REVIEW OF THE DOE REPORT: "THE ORIGIN OF CALCITE-SILICA DEPOSITS AT TRENCH 14 AND BUSTED BUTTE AND METHODOLOGIES USED TO DETERMINE THEIR ORIGIN"

**SPECIAL REPORT No.18
CONTRACT No. 94/96.0003**

**SPECIAL REPORT Submitted to the
Nuclear Waste Project Office
State of Nevada**

November, 1994

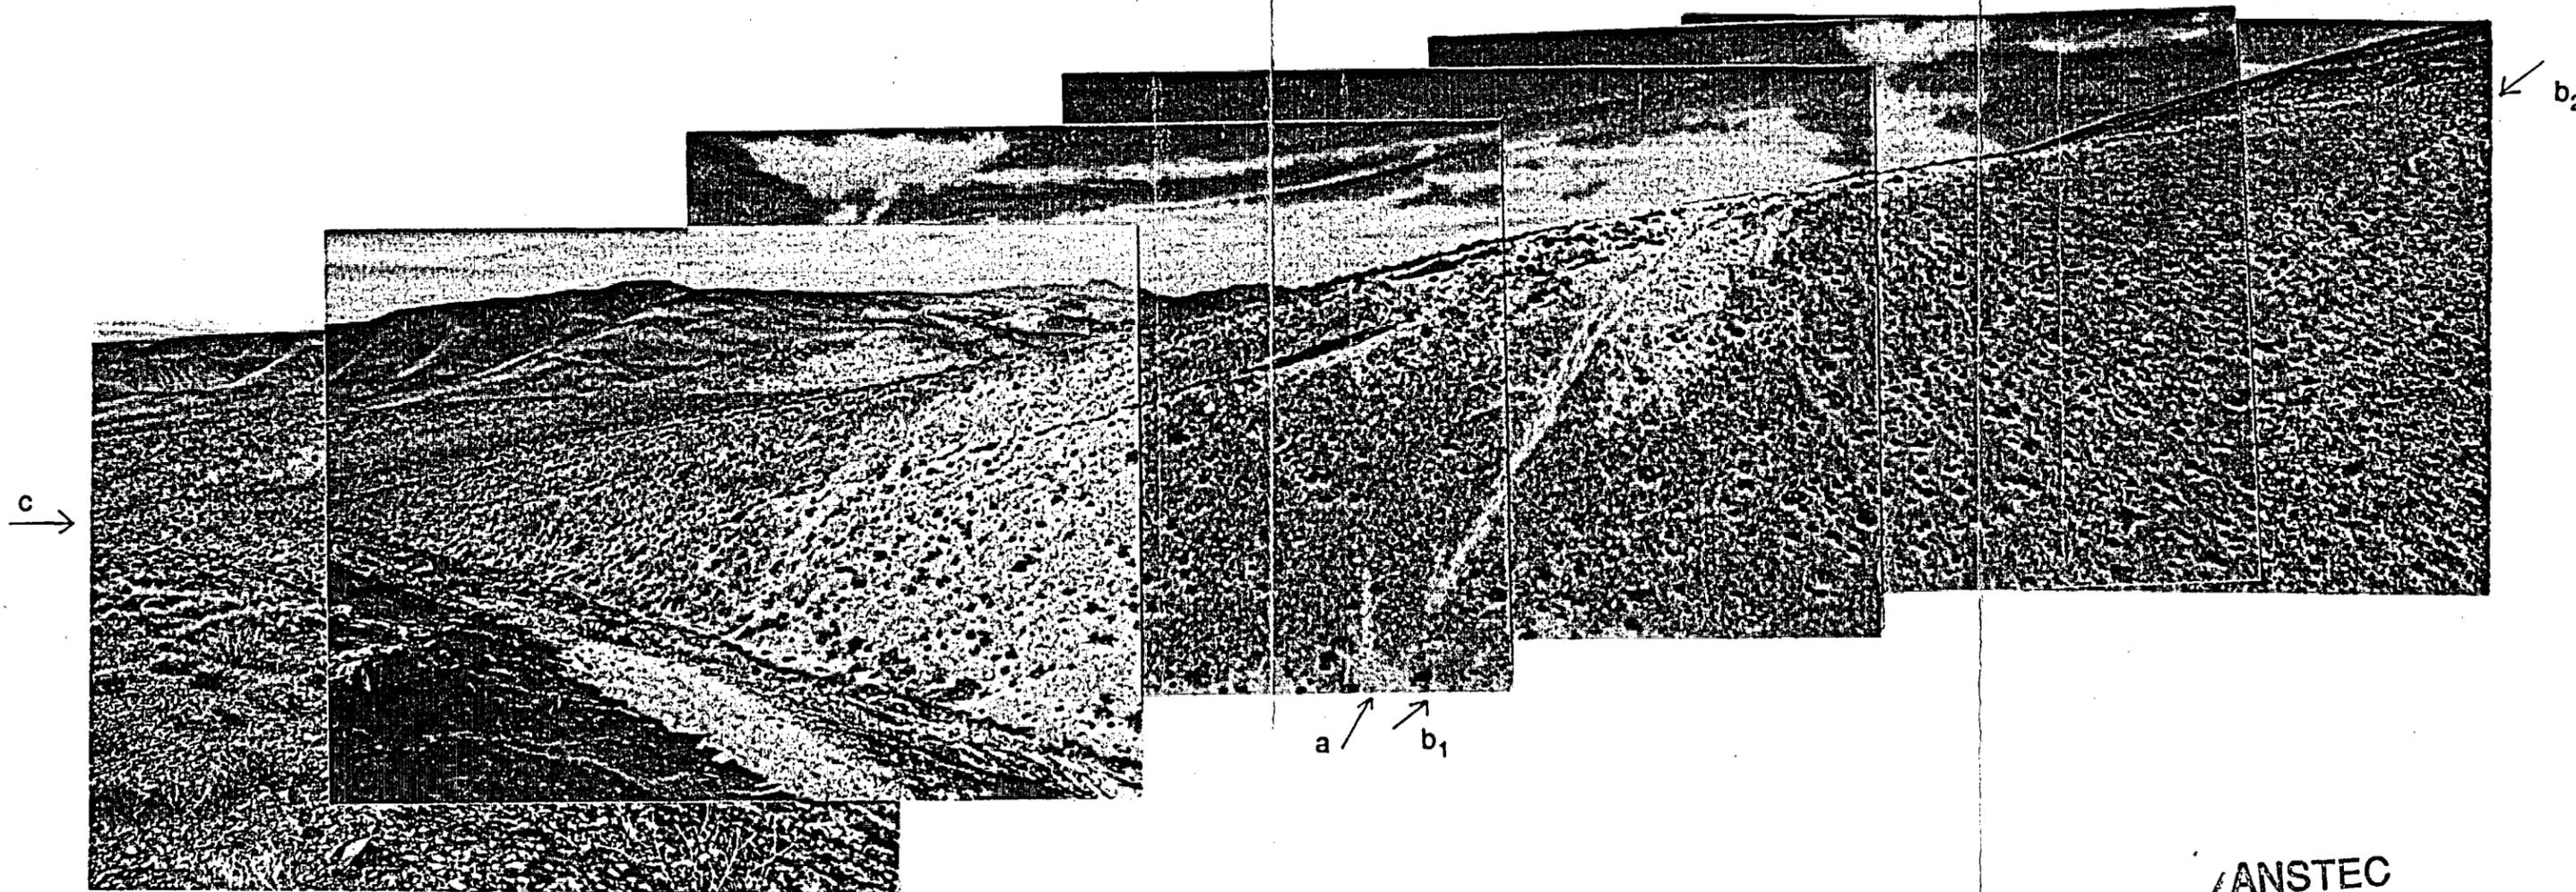
What is missing from this statement is that these slope-parallel deposits are developed mostly downslope of vertical calcite-silica veins, which in turn are developed along fault zones (see Fig. 16 on p.24 of the DOE Report), as should be expected for water

Figure 7 - The relationship between $\delta^{13}\text{O}$ and $\delta^{18}\text{O}$ for pedogenic carbonates and samples from the Trench 14 veins. From DOE, 1993.

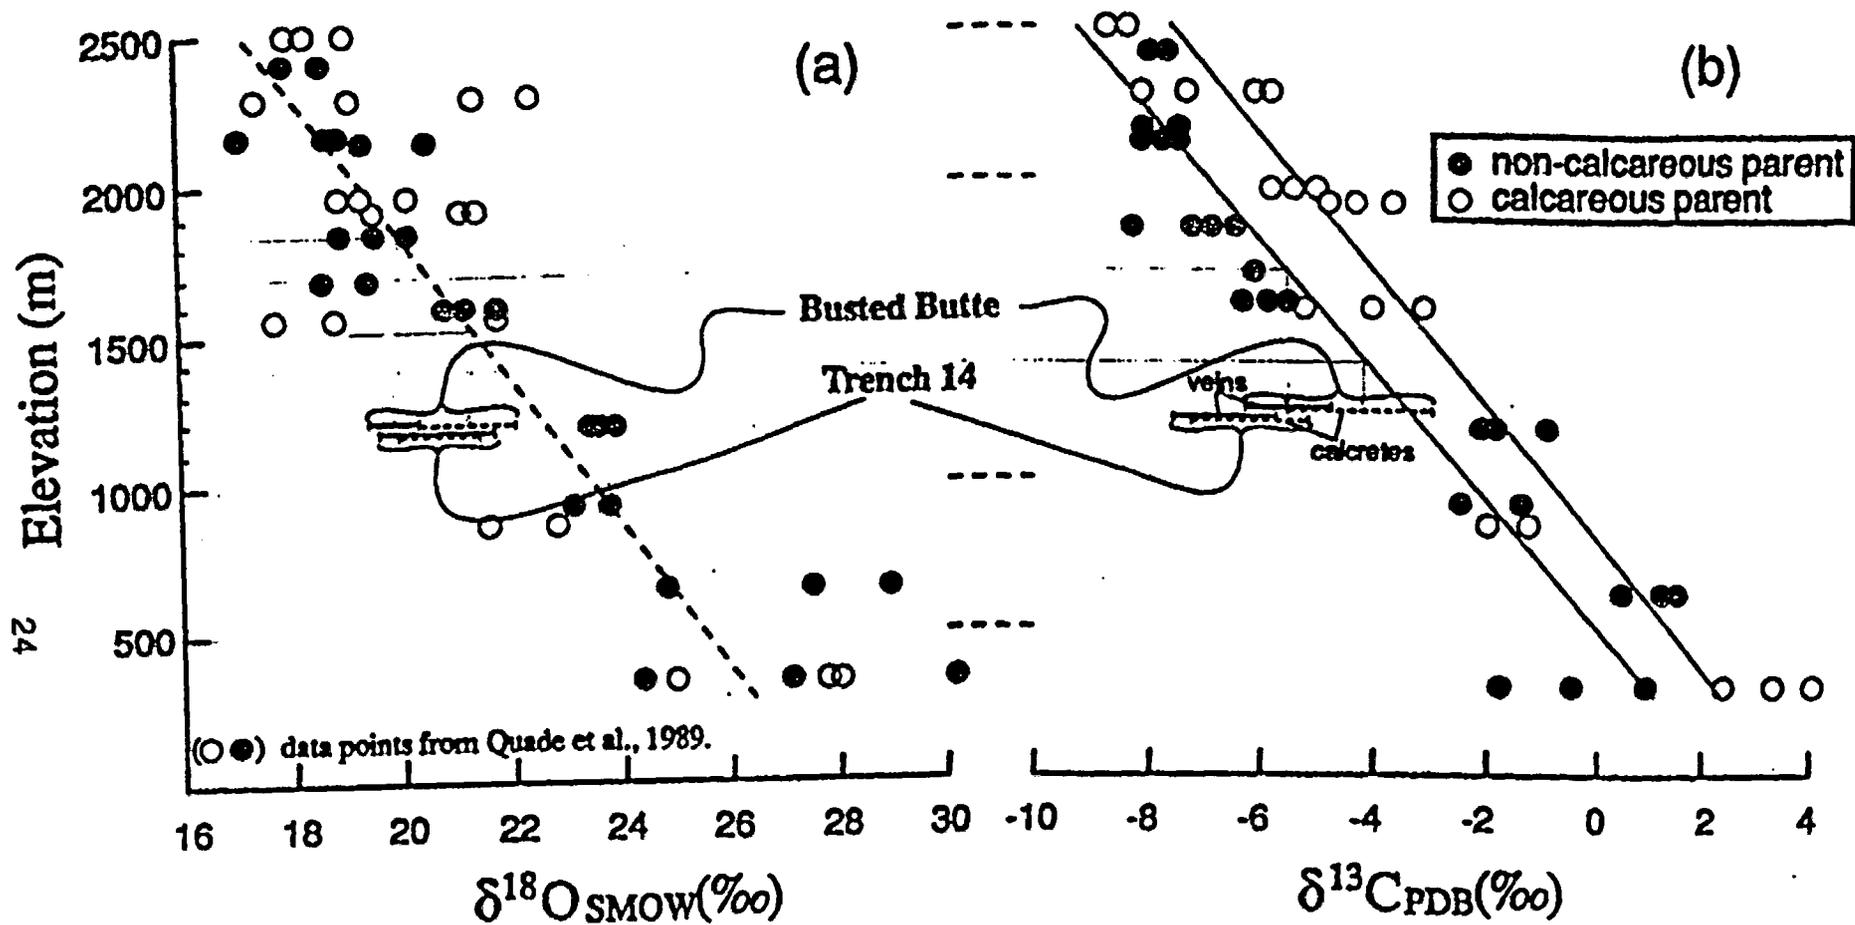
1. One may see from Fig. 10 of the DOE Report that calcretes from both Trench 14 and Busted Butte have $\delta^{18}\text{O}$ and $\delta^{13}\text{C}$ signatures of up to 4,5 permil lighter than pedogenic calcretes at the same altitude; so the statement that the samples are "virtually identical" is not true (Fig. 10 of the DOE Report is reproduced as Fig. 7).
2. It may also be observed, that there is a systematic shift for $\delta^{18}\text{O}$ and $\delta^{13}\text{C}$ in veins and slope calcretes at Busted Butte; both carbon and oxygen are lighter in veins and heavier in slope calcrete (Fig. 8; the data taken from Tables A-1 and A-2 of the DOE Report). Oxygen from Trench 14 displays the same behavior. Using the DOE's logic one must conclude that the veins at Busted Butte were formed at an altitude some 350m higher than the corresponding slope calcretes.

Figure 8 - Systematic change in ^{13}C and ^{18}O in veins and slope calcretes at Busted Butte.

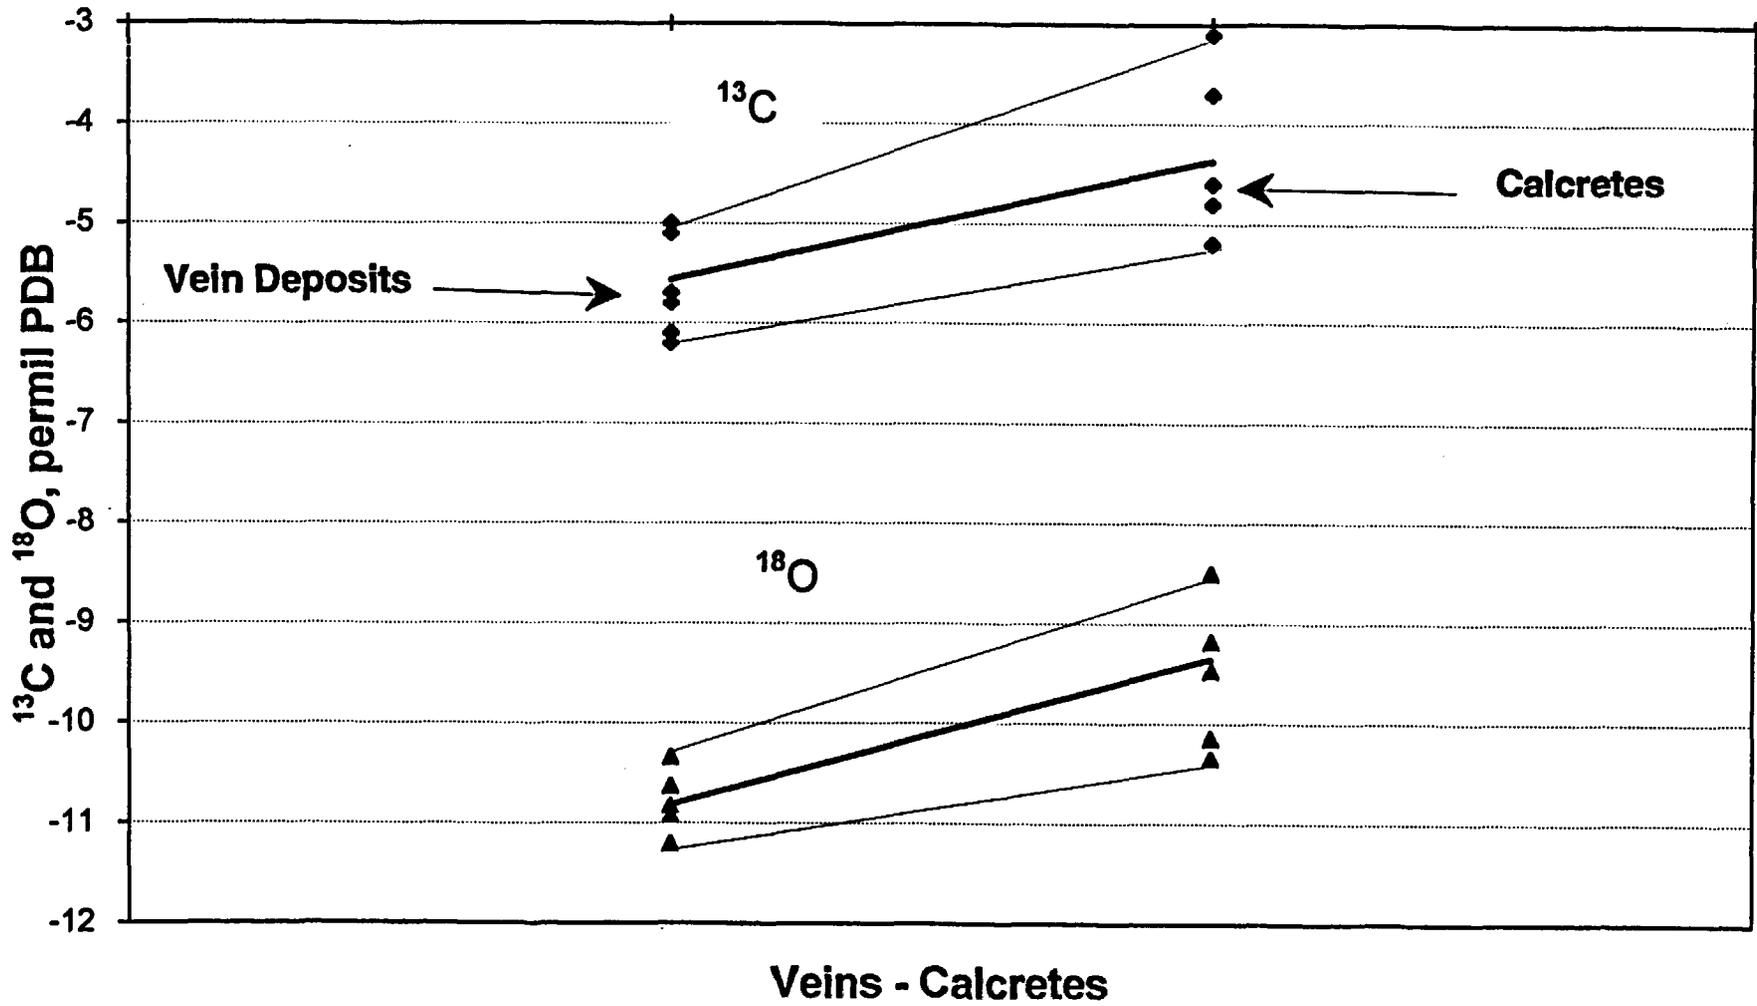
The systematic $\delta^{18}\text{O}$ and $\delta^{13}\text{C}$ shift is not discussed in the DOE Report. Such a behavior, however, may well be expected for *per ascensum* deposits. During deposition of such deposits upwelling fluids (along fault zones and discharging on the topographic surface) lose dissolved CO_2 and evaporate. During both CO_2 -degassing and evaporation the lighter isotopes ^{12}C and ^{16}O preferentially concentrate in the escaping gas phase and, thus, the carbonate-depositing fluids became progressively enriched in heavier isotopes (i.e., ^{13}C and ^{18}O). At Busted Butte, where sand ramps hosting the veins were truncated by erosion and the latter may be sampled to a significant depth from the topographic surface this trend is especially well pronounced. By contrast, in Trench 14 all the vein samples were taken at a depth of only 1-2 m below the topographic surface (see Plates 1-6 in Appendix D of the DOE Report), so the difference between these two types of calcite is less clear.

Figure 9 - ^{18}O in pedogenic carbonates (circles; by Quade et. al., 1988), spring deposits (squares; by Harmon, 1993, Hill and Schluter, 1994), Trench 14 and Busted Butte (triangles; by DOE, 1993). Thick solid line displays linear trend.

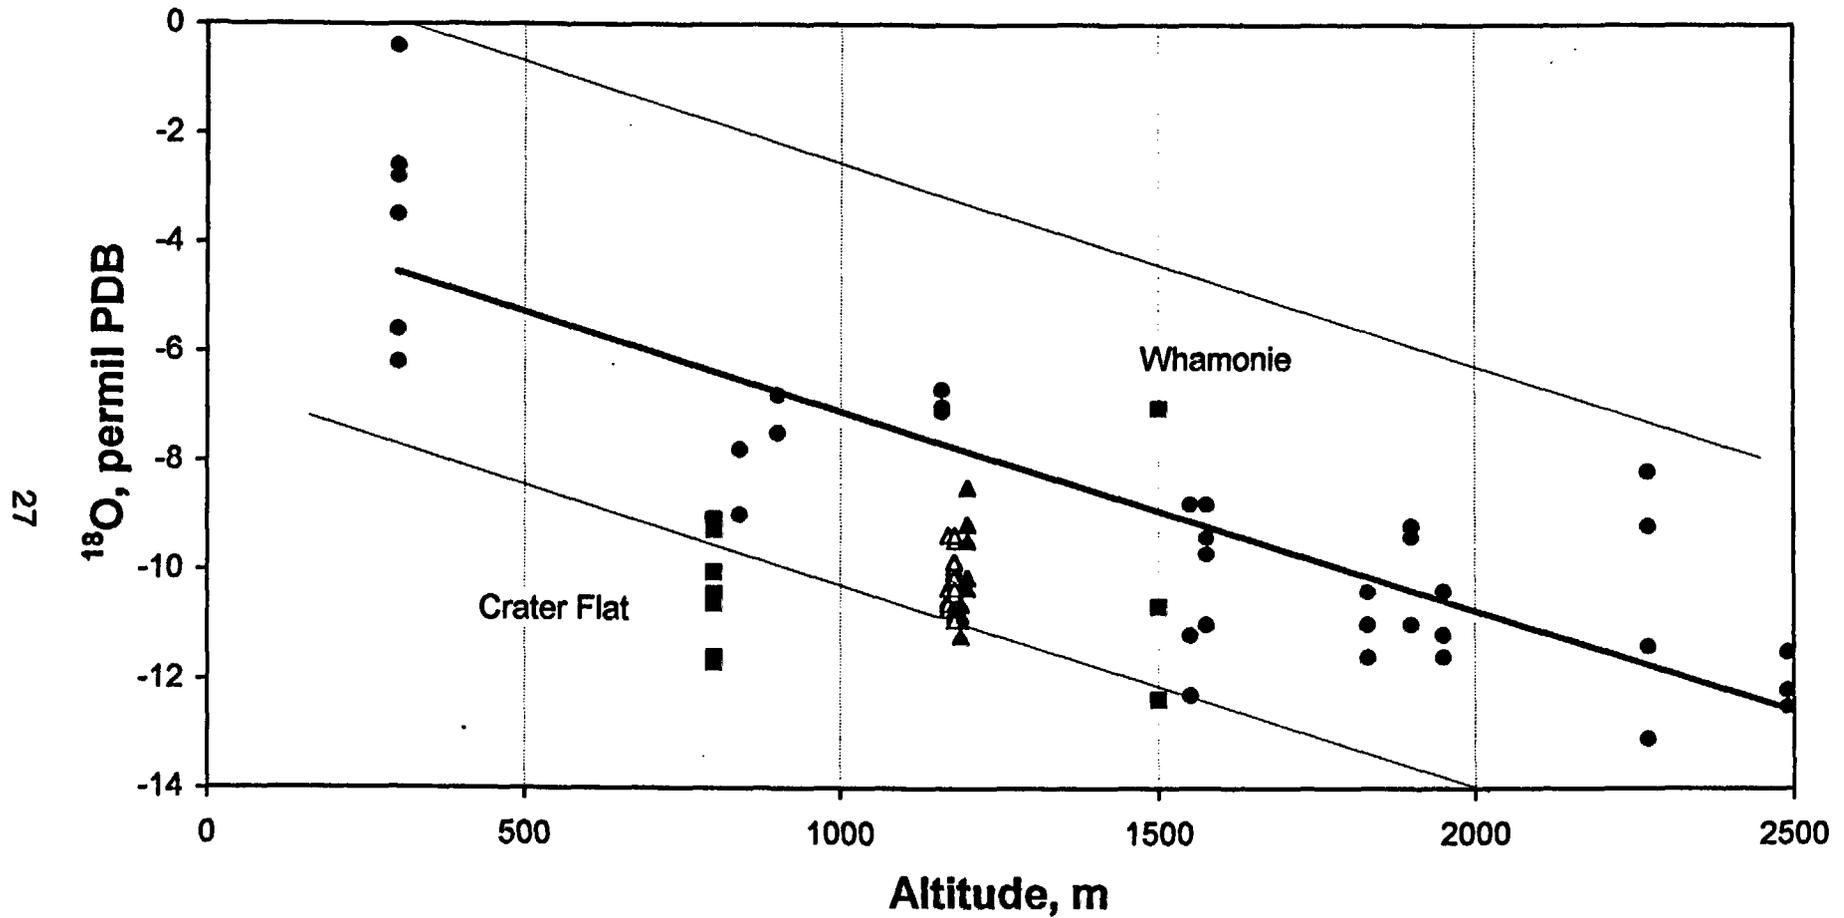
The results given in Figs. 9 and 10 clearly show that stable isotope signatures of calcite deposited from spring water match signatures obtained from "pedogenic" carbonates. As a matter of fact, the match of $\delta^{13}\text{C}$ from spring calcite is much better than that of carbon from calcite at Trench 14 and Busted Butte (Fig. 10). One obvious conclusion which can be drawn from these data is that, at Yucca Mountain, both

Figure 10 - ^{13}C in pedogenic carbonates (circles; by Quade et. al., 1988), spring deposits (squares; by Harmon, 1993, Hill and Schluter, 1994), Trench 14 and Busted Butte (triangles; by DOE, 1993). Thick solid line displays linear trend.

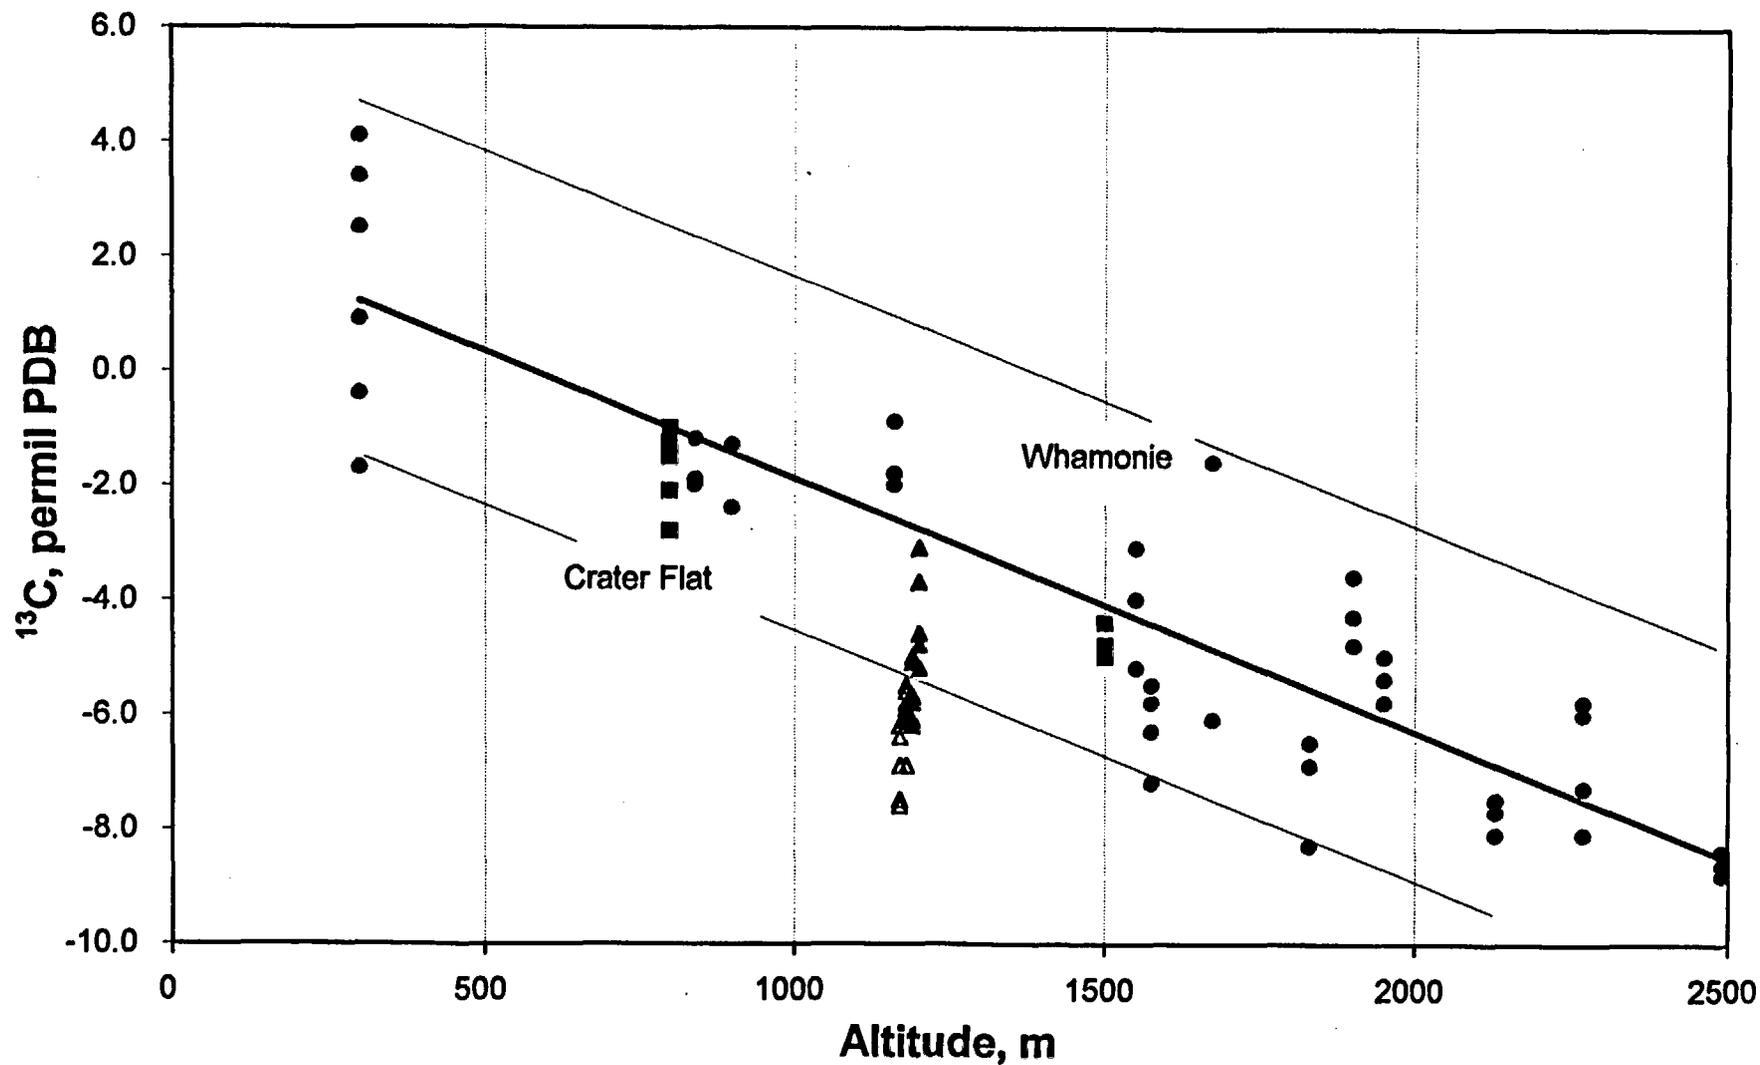
pedogenic process and ascending warm water would produce calcite with identical $\delta^{13}\text{C}$ and $\delta^{18}\text{O}$ signatures, and thus, these signatures can not be used to distinguish between the competing processes.
